# Product Change Notification

## 113526 - 00

**Change Notification #:** 113526 - 00  
**Change Title:** Intel® Server System R2308GL4GS  
PCN 113526-00, Product Design  
Update the System Rear Panel  
**Date of Publication:** December 17, 2014

Figure One

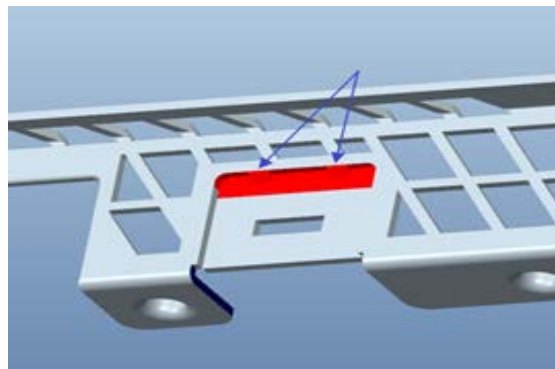
1. Update the one big center joint to two smaller joints so that the joints will not conflict with the LAN cable connector latch. See Figure One.

Figure Two

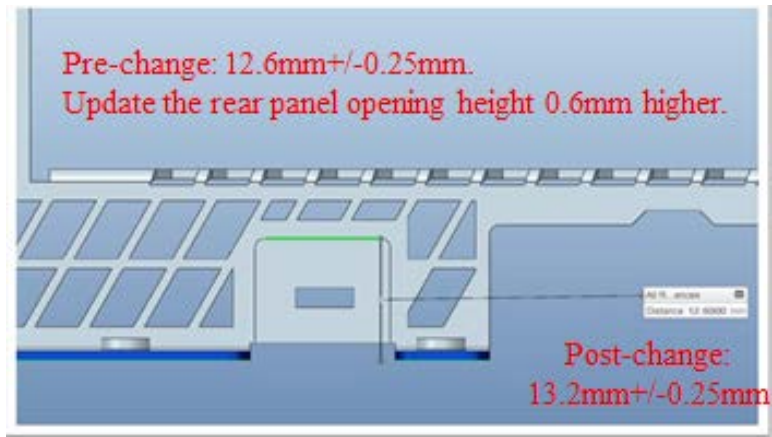
2. Update the rear panel opening height 0.6mm higher to improve the flexibility for the cable latch. The previous height was 12.6mm+/-0.25mm. The updated height is 13.2mm+/-0.25mm. See Figure Two.

Figure Three

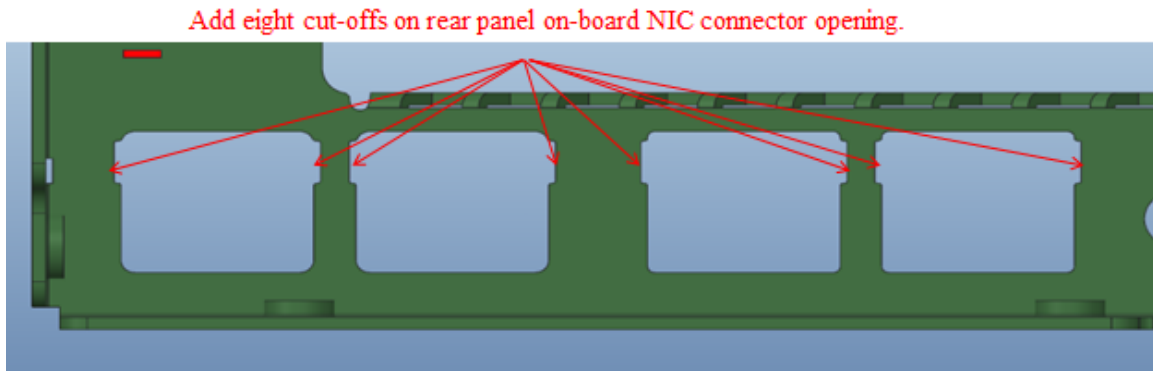
3. Add eight cut-offs around the on-board NIC (Network Interface Controller) openings to improve the LED visibility. See Figure Three.
